**DOS RIOS WRC CHLORINE SYSTEM IMPROVEMENTS**  
**Solicitation Number: CO-00197**  
**Job No.: 17-6508**

**ADDENDUM 3**  
**September 19, 2018**

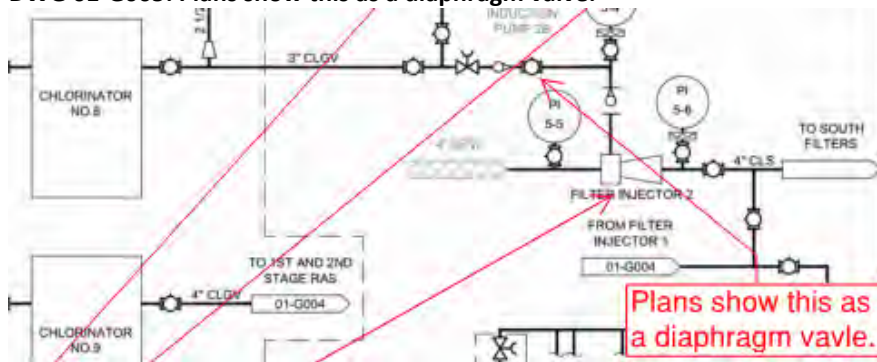
7. **DWG 05-C301: Is anything being done with Pipe 8A?**

**Response:** Pipe 8A is being abandoned in place. Reference notes on DWG 05-X301. Proposed piping legends have been modified in this addendum to show Pipe 8a as existing.

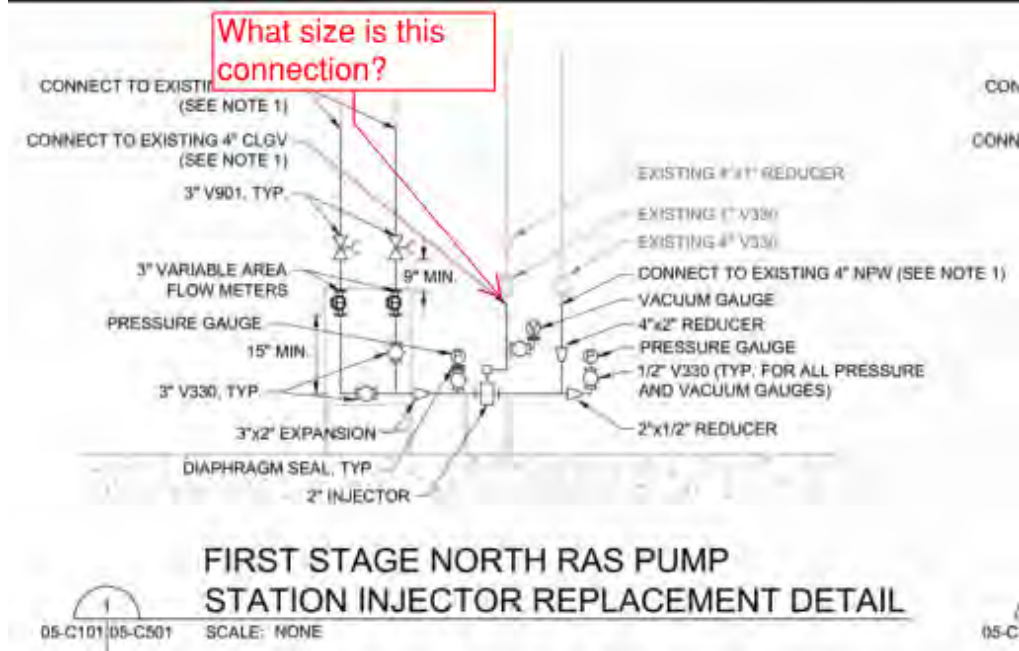
12. DWG 05-C301: What do these lines (1, 2, 3, 9, 8c, 8d) connect to?

**Response:** Lines 1, 2, 3, and 9 connect to the Chlorine Contact Basin Distribution Panels, and lines 8c and 8d connect to the new Recycled Water Injector Panel. Call-outs have been added to revised DWGs 05-C301 and 05-C502, issued in this addendum.

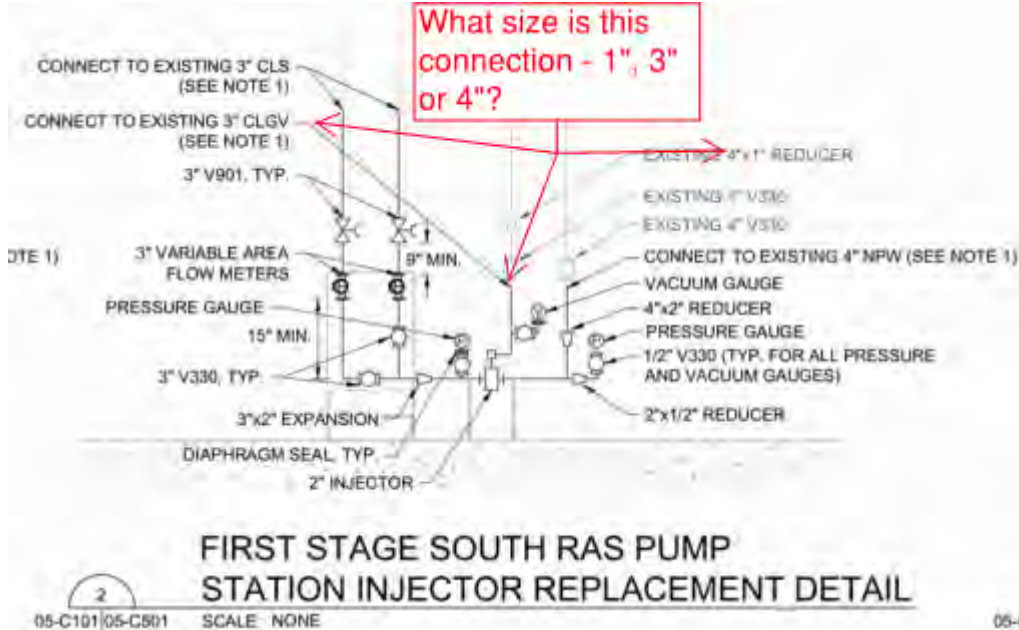
14. DWG 05-C501, Detail 1: What size is this connection?

**Response:** This is a 1" connection. Please reference revised DWG 05-C501, issued in this addendum.

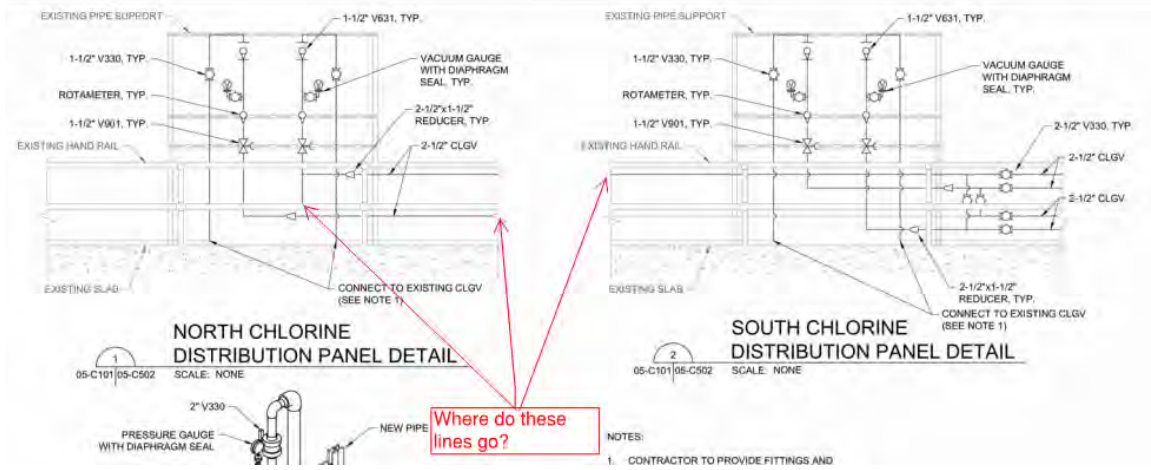
15. DWG 05-C501, Detail 2: What size is this connection?

**Response:** This is a 1" connection. Please reference revised DWG 05-C501, issued in this addendum.

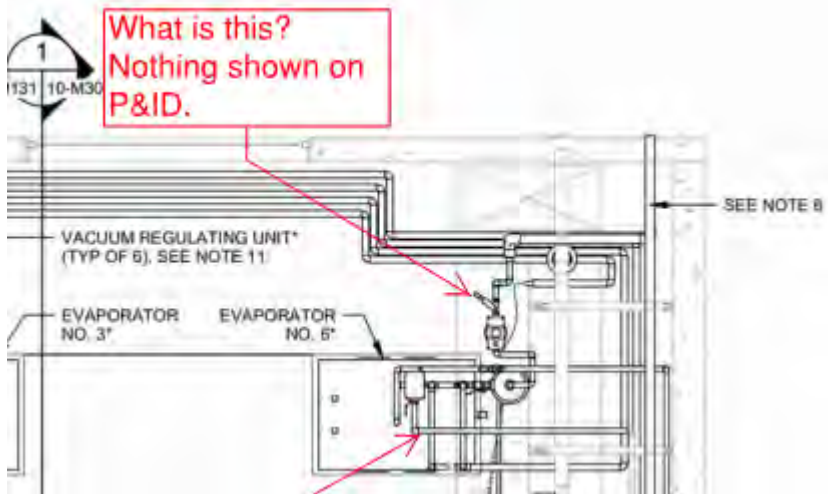
17. DWG 10-M131: Can you provide a section in this direction (North-South, facing west) so we can see the pipe layout that is not hidden by the chlorinators in Section 1/10-M301?

**Response:** The requested section has been added to DWG 10-M301 in this addendum.

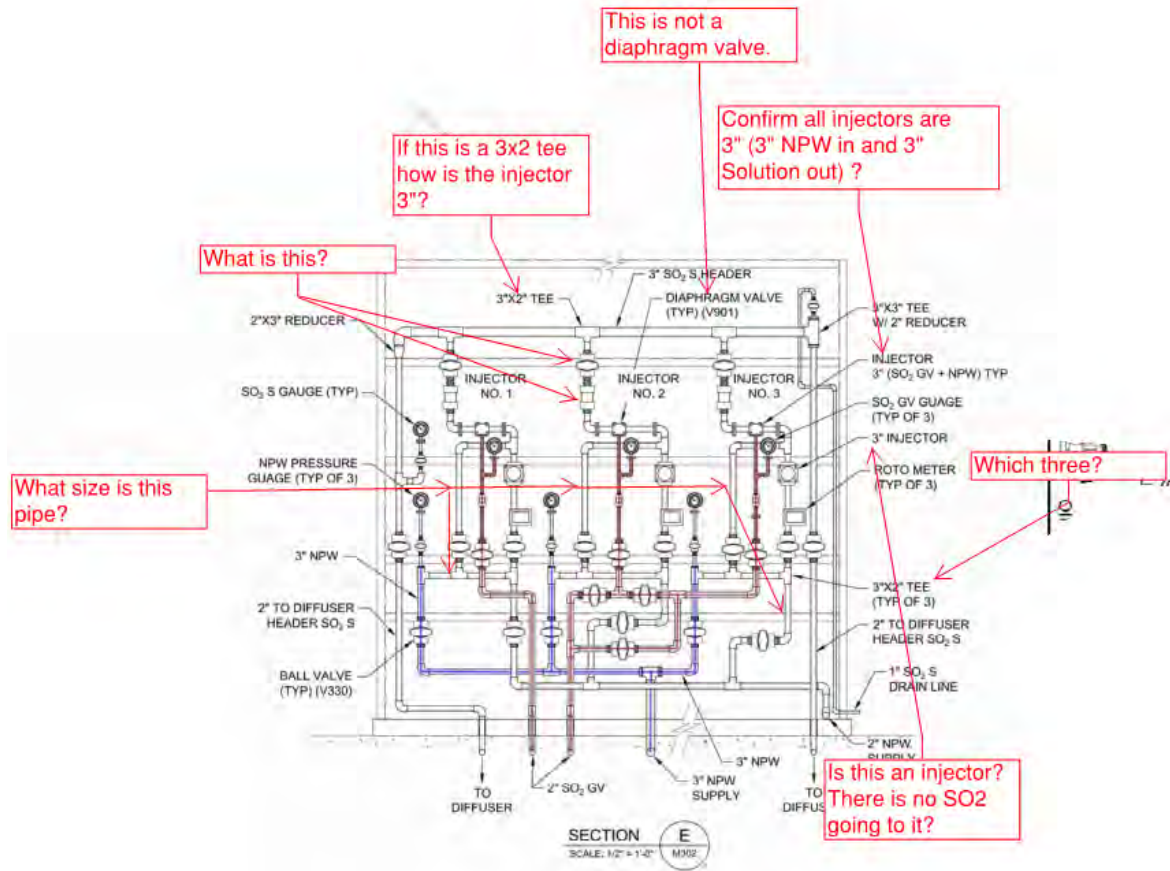
19. DWG 10-M131: What size is the N2 pipe?

**Response:** All N2 pipe in the Disinfection Building is 1”-diameter. Please reference revised DWGs 01-G004, 1-G005, and 10-M131, issued in this addendum.

BAR IS ONE INCH ON ORIGINAL DRAWING  
 IF NOT ONE INCH ON THIS SHEET, ADJUST SCALES ACCORDINGLY.  
 DRAWING NUMBER  
**05-C301**  
 SHEET NUMBER  
**20**

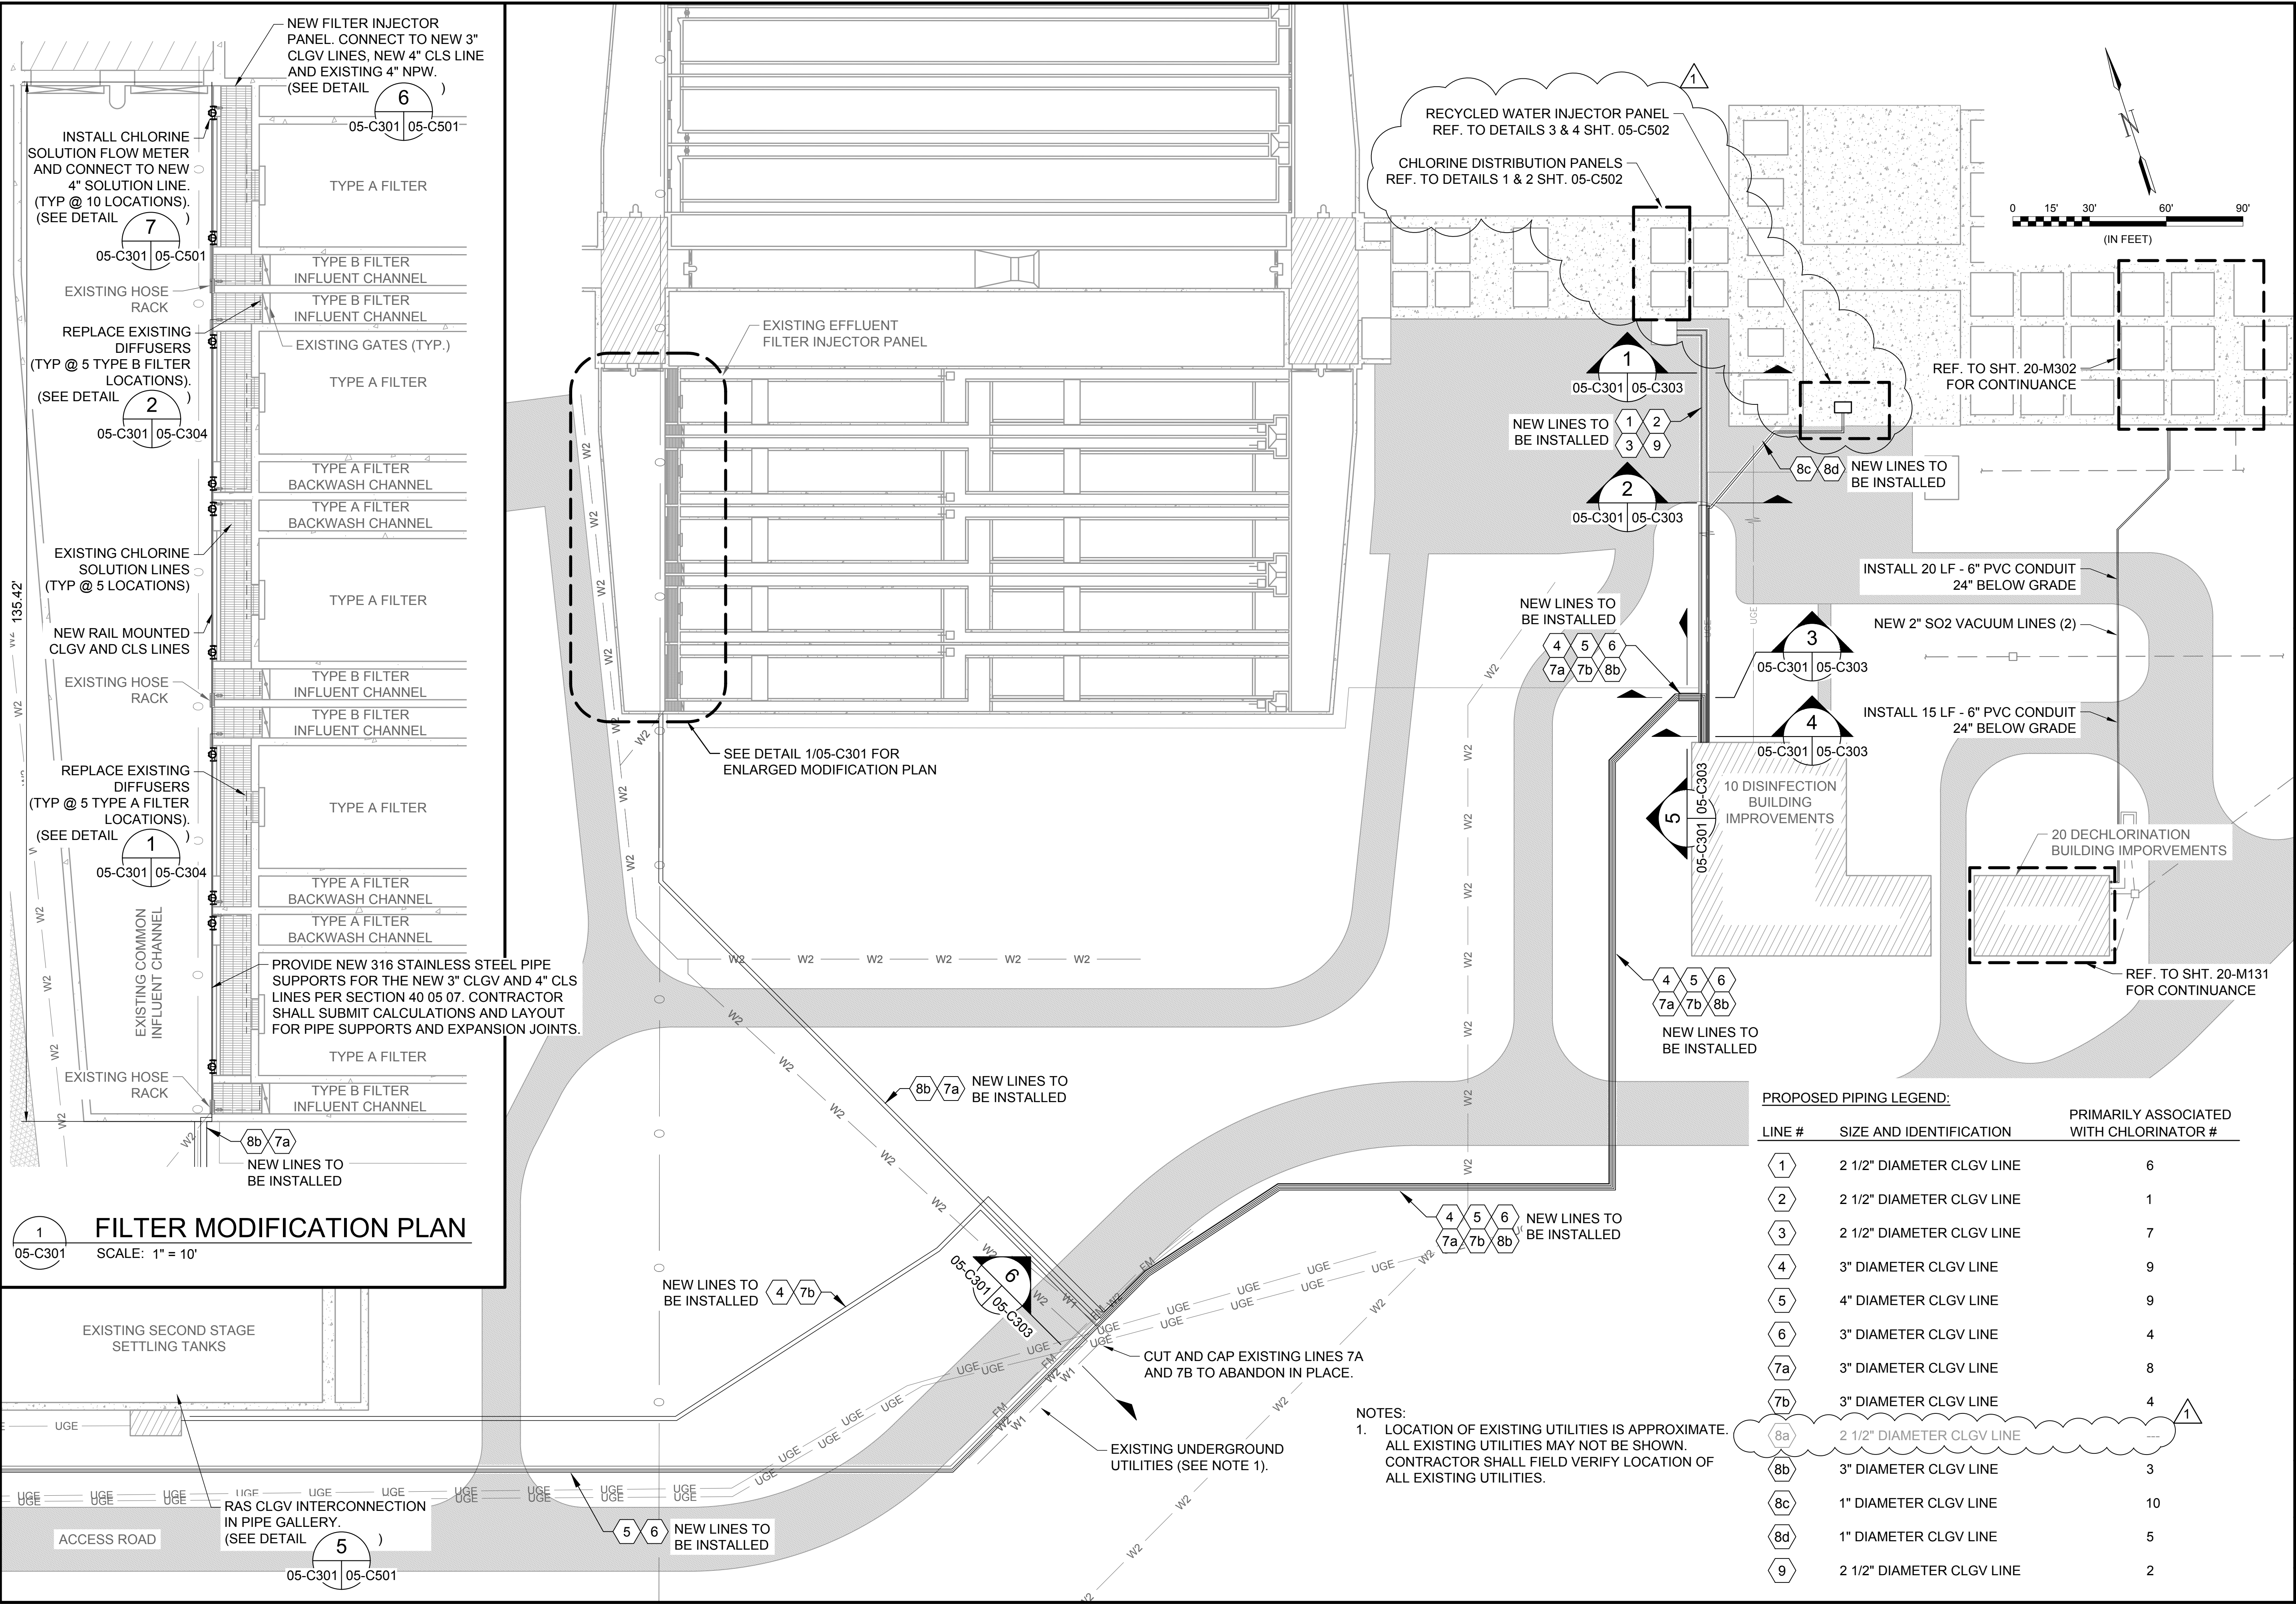
8. Sheets 05-C302 and 05-C304
  - a. Modify the Proposed Piping Legend to show line # 8a as existing.
9. Sheet 05-C501
  - a. Replace the sheet with the attached.

1 PIPING SECTION  
 05-C301 | 05-C303 SCALE: 1" = 1'-0"

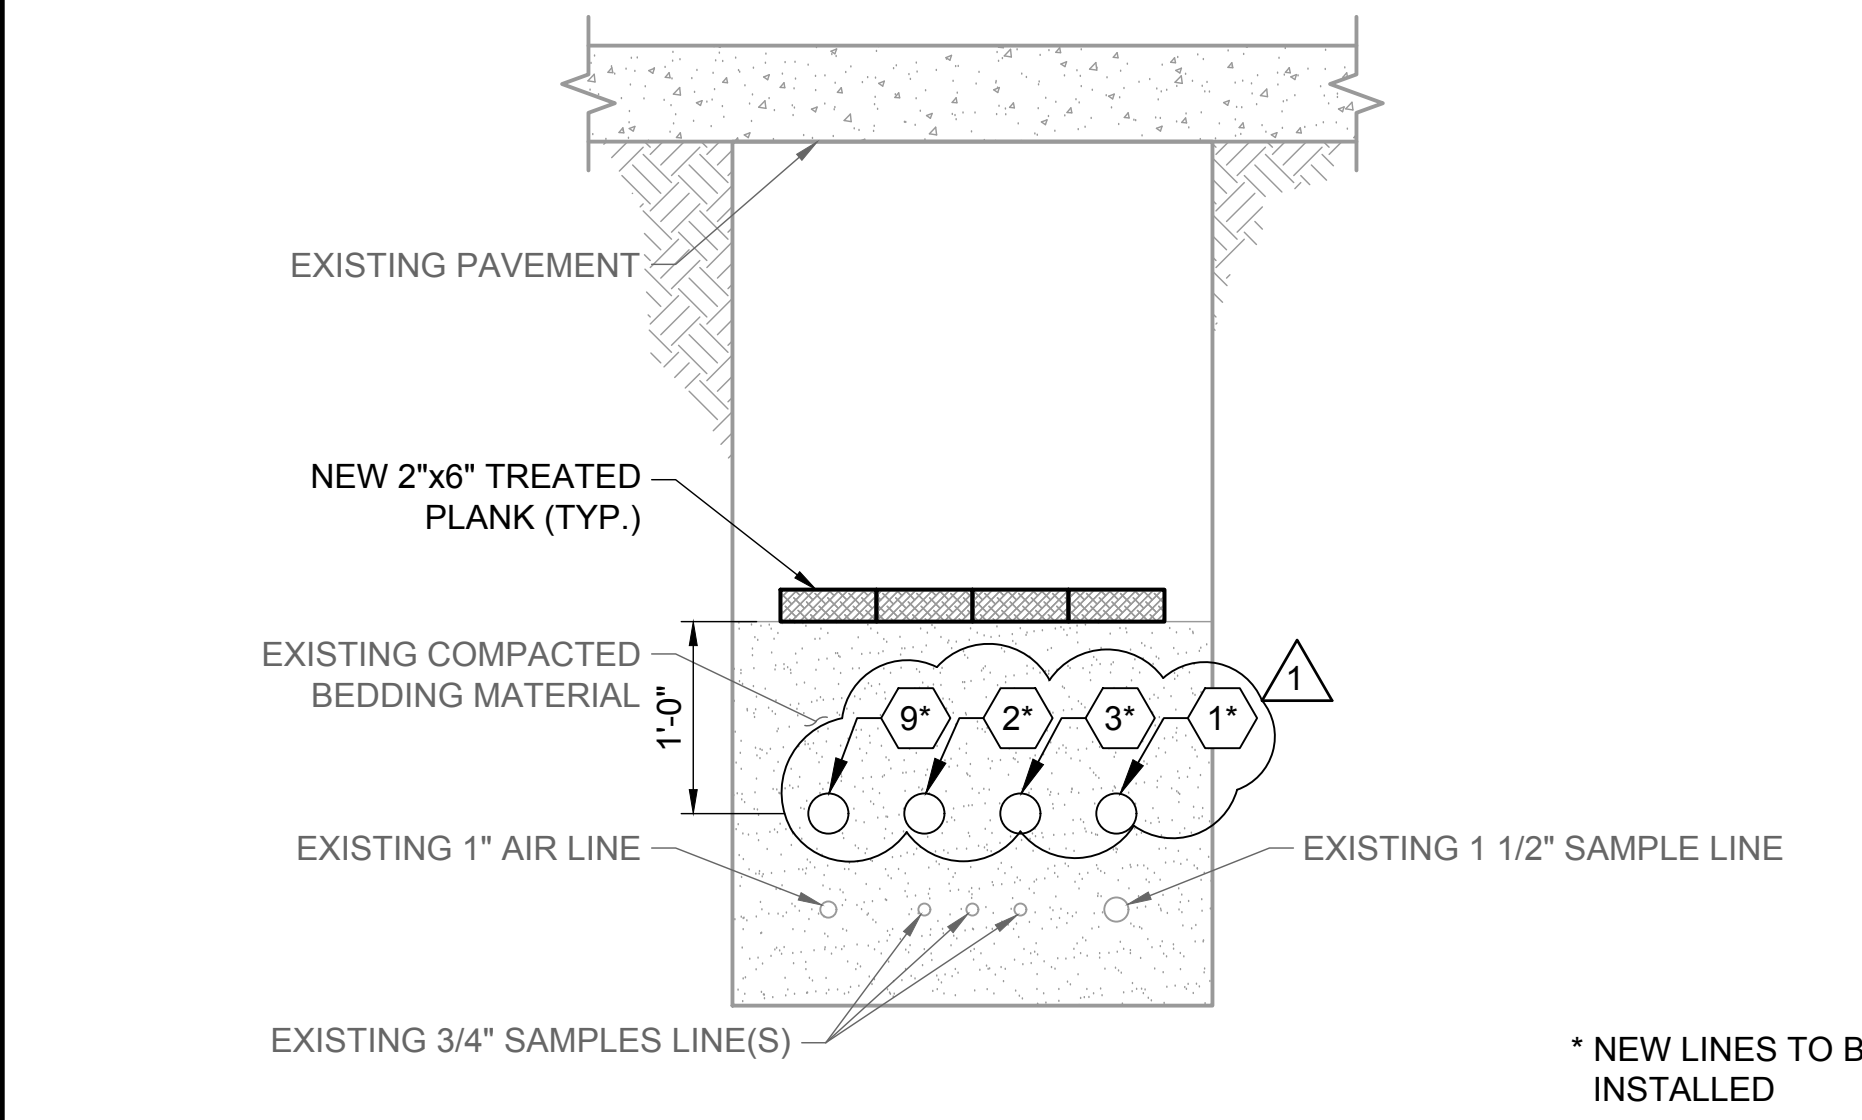
13. DWG 05-C303, Section 1: Are lines 1 and 9 reversed? See Sections 2, 3, and 4.

**Response:** Yes. Reference revised DWG 05-C303, issued in this addendum.
